Application No.	Applicant(s)					
		10/698,091	WORRELL ET AL.					
	Office Action Summary	Examiner	Art Unit					
		Troy Chambers	3641					
	The MAILING DATE of this communication app	1	orrespondence address					
Period for Reply A SHORTENED STATUTORY PERIOD FOR REPLY IS SET TO EXPIRE 3 MONTH(S) OR THIRTY (30) DAYS,								
WHIC - Exter after - If NO - Failu Any r	CHEVER IS LONGER, FROM THE MAILING DA sisions of time may be available under the provisions of 37 CFR 1.13 SIX (6) MONTHS from the mailing date of this communication. period for reply is specified above, the maximum statutory period we tee to reply within the set or extended period for reply will, by statute, eply received by the Office later than three months after the mailing and patent term adjustment. See 37 CFR 1.704(b).	ATE OF THIS COMMUNICATION 36(a). In no event, however, may a reply be tim- rill apply and will expire SIX (6) MONTHS from to cause the application to become ABANDONED	l. ely filed the mailing date of this communication. D (35 U.S.C. § 133).

DETAILED ACTION

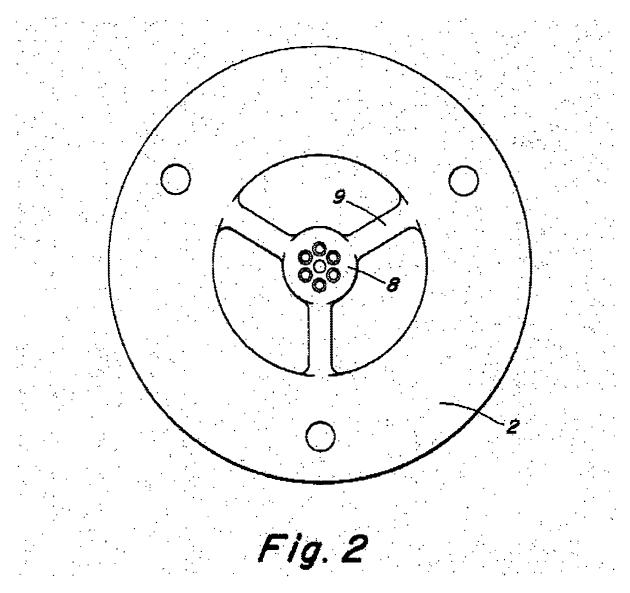
- (b) the invention was patented or described in a printed publication in this or a foreign country or in public use or on sale in this country, more than one year prior to the date of application for patent in the United States.
- 2. Claims 1-7 and 13-15 are rejected under 35 U.S.C. 102(b) as being clearly anticipated by US 3778217 issued to Bustamante et al.

4. Claim 10 is rejected under 35 U.S.C. 103(a) as being unpatentable over Bustamante. Bustamente discloses an extrusion die as shown above. However, Bustamente does not disclose a pin shape that is non-round. At the time of the invention, it would have been obvious to one having ordinary skill in the art to make the pins of Bustamente to be non-round since it has been held that such changes are a matter of design choice. In re Dailey, 357 F.2d 669, 149 USPQ 47 (CCPA 1966) (The court held that the configuration of the claimed disposable plastic nursing container was a matter of choice which a person of ordinary skill in the art would have found obvious absent persuasive evidence that the particular configuration of the claimed container was significant.) Moreover, the applicant's specification did not mention that such a shape is critical to the operation of the invention.
